TRANS/WP.29/2005/86
29 July 2005

World Forum for Harmonization of Vehicle Regulations (WP.29)

**PROPOSAL FOR SUPPLEMENT 1 TO THE 04 SERIES OF AMENDMENTS
TO REGULATION No. 44**

(Child restraint systems)

"Annex 7 – Appendix 1

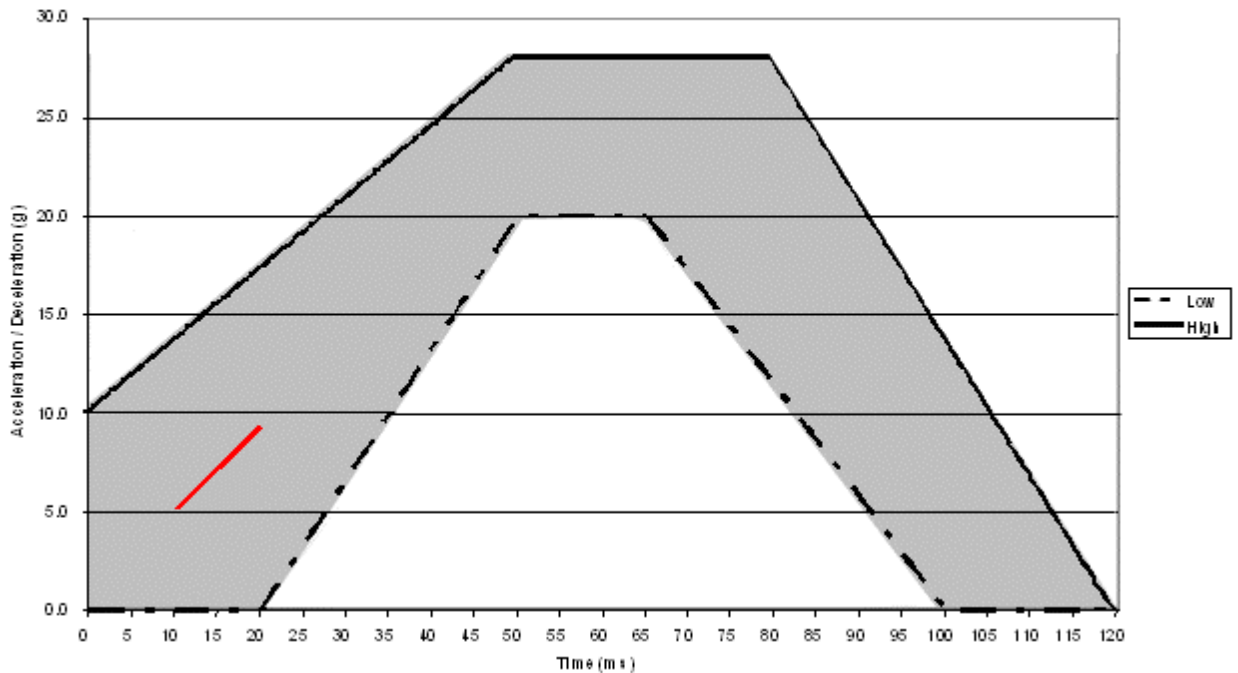
Annex 7, Appendices 1 and 2, amend to read:

The additional segment (see paragraph 8.1.3.1.1.3.2.) applies only for the acceleration sled

For frontal impact, the trolley shall be so propelled that, during the test, its total velocity change ΔV is $52 + 0 - 2$ km/h and its acceleration curve is within the hatched area of the graph in Annex 7, Appendix 1 and stay above the segment defined by the coordinates (5g, 10ms) and (9g, 20ms). The start of the impact (T0) is defined, according to ISO DIS 17 373 for a level of acceleration of 0.5 g.

Time (ms)	Acceleration (g) Low corridor	Acceleration (g) High corridor
0	-	10
20	0	-
50	20	28
65	20	-
80	-	28
100	0	-
120	-	0

Annex 7 – Appendix 2

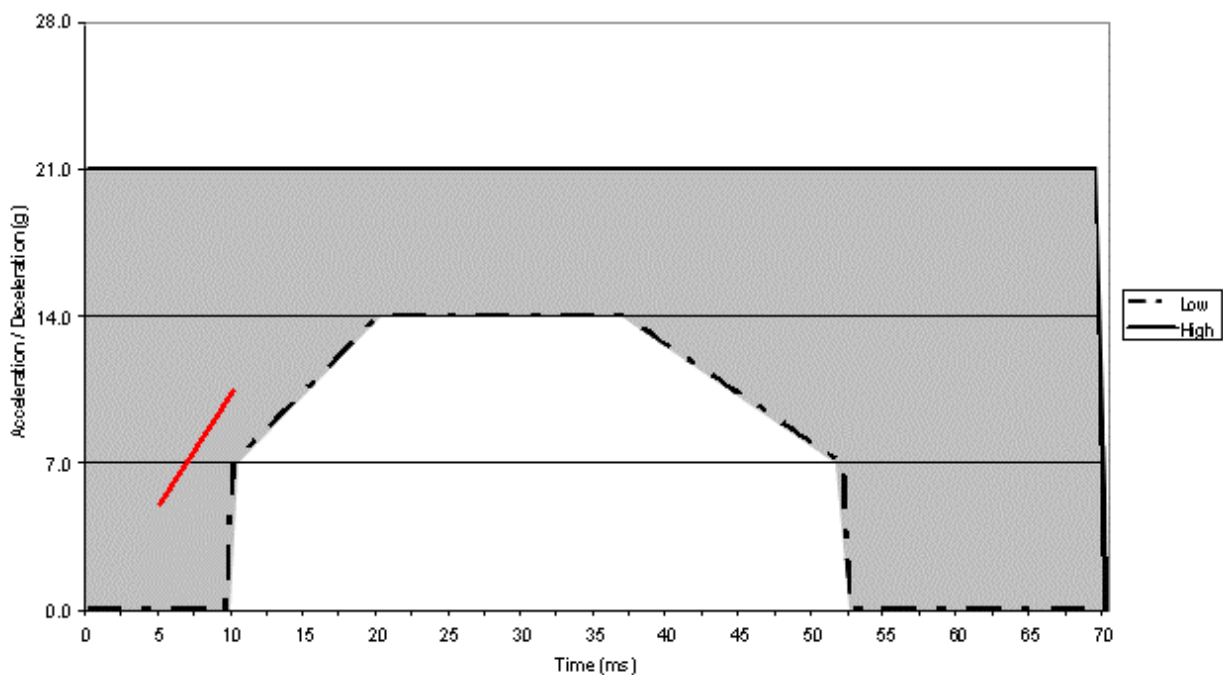
The additional segment (see paragraph 8.1.3.1.1.3.2.) applies only for the acceleration sled"

For rear impact, the trolley shall be so propelled that, during the test, its total velocity change ΔV is $32 + 2 - 0$ km/h and its acceleration curve is within the hatched area of the graph in Annex 7, Appendix 2 and stay above the segment defined by the coordinates (5g, 5ms) and (10g, 10ms). The start of the impact (T0) is defined, according to ISO DIS 17 373 for a level of acceleration of 0.5 g.

Time (ms)	Acceleration (g) Low corridor	Acceleration (g) High corridor
0	-	21
10	0	
10	7	-
20	14	-
37	14	-
52	7	-
52	0	
70	-	21
70	-	0
